Access Compliance Report

Public Rights-of-Way

(Curb Ramps)

Intersection ID: 10020349	Main Street: BALLANTYNE COMMONS PY	Cross Street: N/A	Location: NE
ADA ID: F84D7C55849E	Ramp Type: Perp	Initial Pass/Fail: Fail	Overall Compliance: No
Codes/Mitigation Info/Possible Solution		Field Measurements/Component Compliance	
Severity Score: 46.25

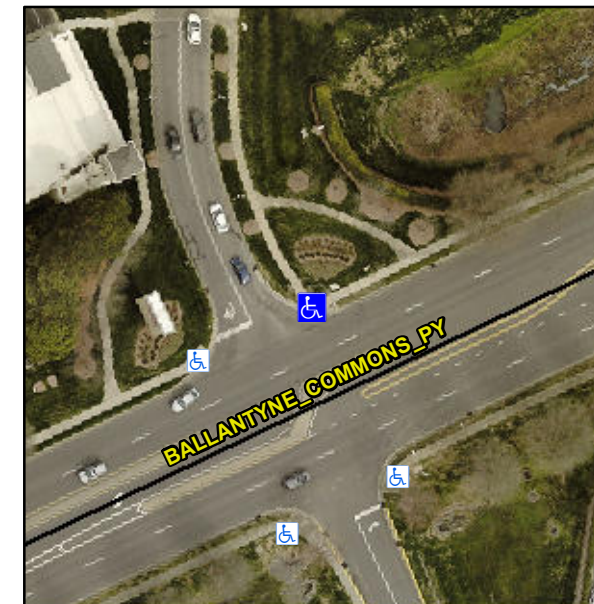
Not Found, R304.5.1, R304.2.2, R304.5.3

Compliance	Description	Data	Compliance	Description	Data
N/A	Ramp Length (in)	78.0	No	Ramp Slope (%)	8.8
No	Ramp Width (in)	43.0	No	Ramp XSlope (%)	7.3
N/A	Flare Type LT	N/A	N/A	Flare Type RT	N/A
N/A	Flare Slope LT (%)	N/A	N/A	Flare Slope RT (%)	N/A
N/A	Flare Traversable LT?	N/A	N/A	Flare Traversable RT?	N/A
N/A	Landing Length (in)	N/A	N/A	DWS Provided?	N/A
N/A	Landing Width (in)	N/A	N/A	DWS Contrast?	N/A
N/A	Landing Slope (%)	N/A	N/A	DWS Length (in)	N/A
N/A	Landing X Slope (%)	N/A	N/A	DWS Full Width?	N/A
N/A	Landing Curb? (Y/N)	N/A	N/A	DWS Offset (in)	N/A
N/A	Shared Landing?	N/A			
N/A	Gutter Ponding?	N/A	N/A	Gutter Slope (%)	N/A
N/A	Gutter Lip Ht (in)	N/A	N/A	Gutter X Slope (%)	N/A
N/A	Painted X Walk1?	No	N/A	Painted X Walk2?	N/A
	X Walk 1 Direction	To W		X Walk 2 Direction	N/A
N/A	X Walk 1 Width (in)	N/A	N/A	X Walk 2 Width (in)	N/A
	X Walk 1 Slope (%)	3.6		X Walk 2 Slope (%)	N/A
	X Walk 1 X Slope (%)	3.7		X Walk 2 X Slope (%)	N/A

Remove & Replace Entire Ramp.
